PRODUCT IMPROVEMENT PROGRAM FOR REPLACING THE AFTERTREATMENT REGENERATION DEVICE (ARD) COMBUSTION BODY ON CERTAIN C15 ON-HIGHWAY TRUCK ENGINES

Media Number -REBE4750-01

**PRODUCT IMPROVEMENT PROGRAM FOR REPLACING THE
AFTERTREATMENT REGENERATION DEVICE (ARD)
COMBUSTION BODY ON CERTAIN C15 ON-HIGHWAY TRUCK
ENGINES**

PI10732

Image1.1.1

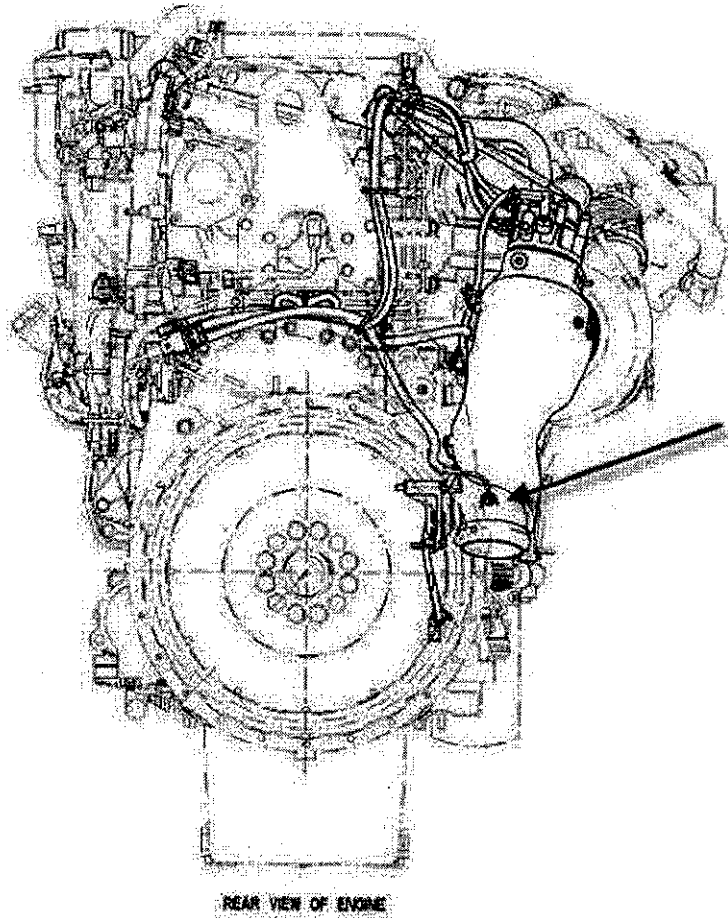
1. Perform an ECM warranty download using Cat ET.
2. Remove combustion head group (ARD). Refer to RENR9706 "Combustion Head Group (ARD) - Removal Procedure".
3. Loosen the OEM band clamp at the bottom of the combustion body and remove the extension pipe attached to the combustion body.
4. Disconnect the temperature sensor located at the bottom of the combustion body. Refer to Image 1.1.1

11. Install the two bolts that attach the combustion body to the support bracket. Refer to Image 1.2.1
12. Apply anti-seize compound to the threads of the temperature sensor located at the bottom of the combustion body and install. Refer to Image 1.1.1

Image1.1.2

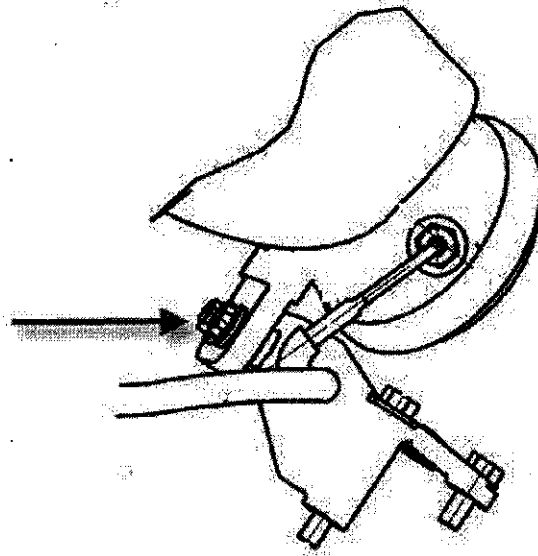
5. Remove the two bolts that attach the combustion body to the support bracket. Refer to Image 1.1.2
6. Disconnect the temperature sensor located on the back of the combustion body near the top.

Image1.2.1

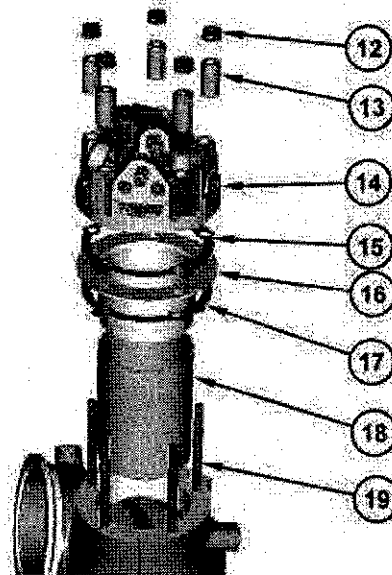
15. Apply anti-seize compound to the threads of studs (19). Install studs (19) with the end that is marked "X" in the Up position. Tighten studs (19) to a torque of 17 +/- 2 N.m (12.5 +/- 1.5 lb ft). Install tube (18). Refer to Image 1.2.1 and Image 1.2.2

Image1.3.1

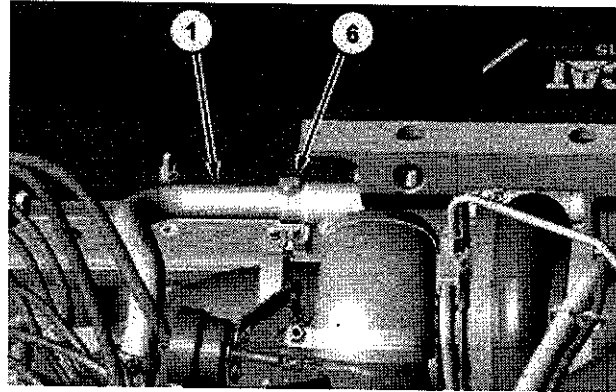
17. Install a new 289-3107 gasket (not pictured) between the 288-6036 tube assembly (1) and ARD Head. Tighten clamp (6). Refer to Image 1.3.1
